UNITED STATES PATENT AND TRADEMARK OFFICE

10/589,781

Office Action Summary	Application No. 10/589,781	Applicant(s) ITOH ET AL.	
	Examiner ROBERT R. RAINEY	Art Unit 2629

DETAILED ACTION

FIG. 95(a)

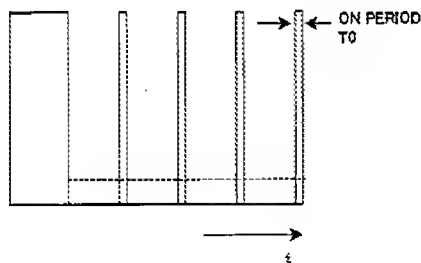
seems misguided since the incorporation of equal small pulses in an otherwise "off period" is exactly the invention that applicant is claiming as can be seen in Fig. 95(a) of the instant application. Both Miyachi Fig. 46 and IA Fig. 95(a) show

a primary pulse and four shorter secondary pulses within a frame time. Examiner fails to see how the one is not like the other.

Fig. 95(a) of the instant application and Fig. 46 of Miyachi are reproduced below for reference.

FIG. 46

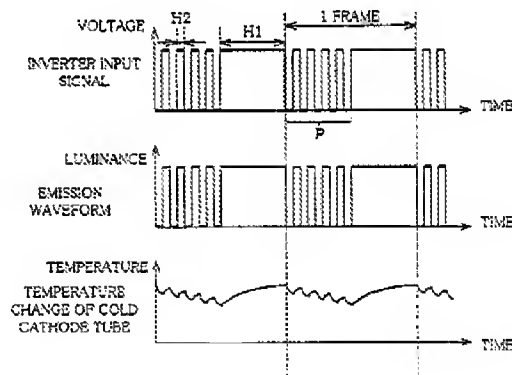
said device emitting a first light emission component (see for example Fig. 46 emission period "H1") and a second light emission component (see for example Fig. 46 the emission period "P"),

a set of conditions A: $62 \leq S < 100$, $0 < D < 100$, and $D < S$, (see for example Fig. 46, which shows D roughly = 50 and S roughly = 69) or

the second light emission component is formed by a collection of pulse components having a higher frequency than a vertical frequency of the video signal (see for example Fig. 46 in which the emission period "P" includes a plurality of pulses of length "H2"; 4.5 cycles are shown within 1/2 frame time making the frequency of the pulses approximately 9 times the vertical frequency of the video signal in the example).

$D/2 \leq P \leq 100 - D/2$, and $0 < D < 100$, where P is a ratio in percentages of a duration to the vertical cycle, the duration beginning at a start of the vertical cycle and ending at a midpoint of a light emission period associated with the first light emission component (see for example Fig. 46, which shows D roughly = 50 and P roughly = 75 and the "H1" or D period falling within a frame time).

$P=50+K$ for $0 \leq K \leq (50-D/2)$ (see for example Fig. 46, which shows D roughly = 50, K roughly = 25 and P roughly = 75), where K is a constant dictated by a response time constant of the video display means (see for example [0350]-[0351] especially "until the response of the liquid crystal of the pixels therein is substantially complete"; note that changing the ON location changes K). (As noted above, examiner found the lower limit for K , "0", at [0633] of the PGPUB.)
